APPLICATION FOR MODIFICATION ASSESSMENT REPORT

Application Number:	Mod2022/0376
Responsible Officer:	Adam Croft
Land to be developed (Address):	Lot 38 DP 7236, 23 Bassett Street MONA VALE NSW 2103 Lot 2 DP 748426, 33 Bassett Street MONA VALE NSW 2103
Proposed Development:	Modification of Development Consent DA2020/0816 granted for Demolition works and construction of a Seniors Housing Development (Residential Care Facility)
Zoning:	R2 Low Density Residential
Development Permissible:	Yes, under SEPP (Housing for Seniors or People with a Disability) 2004
Existing Use Rights:	No
Consent Authority:	Northern Beaches Council
Land and Environment Court Action:	No
Owner:	Thompson Health Care Pty Ltd
Applicant:	Thompson Health Care Pty Ltd

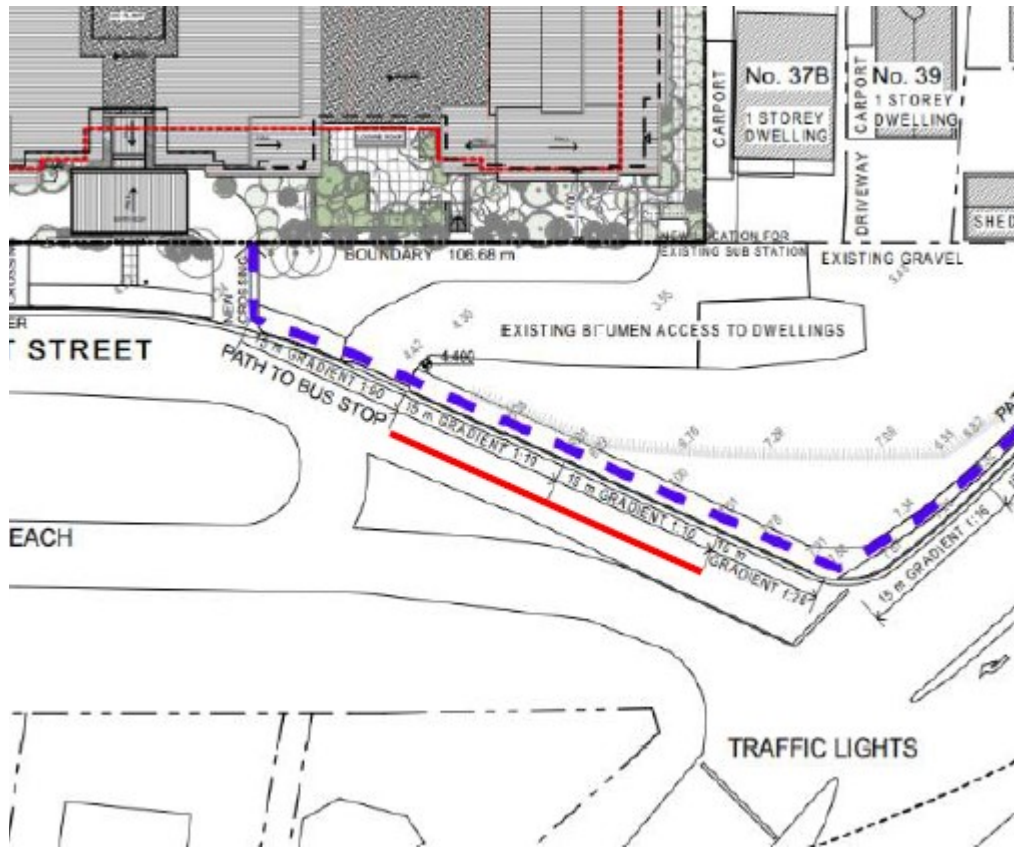
Comment:

The non-compliant section of the existing footpath is shown on the below plan excerpt.

Therefore, the applicant's written request has adequately demonstrated that there are sufficient environmental planning grounds to justify contravening the development standard as required by cl 4.6 (3)(b).
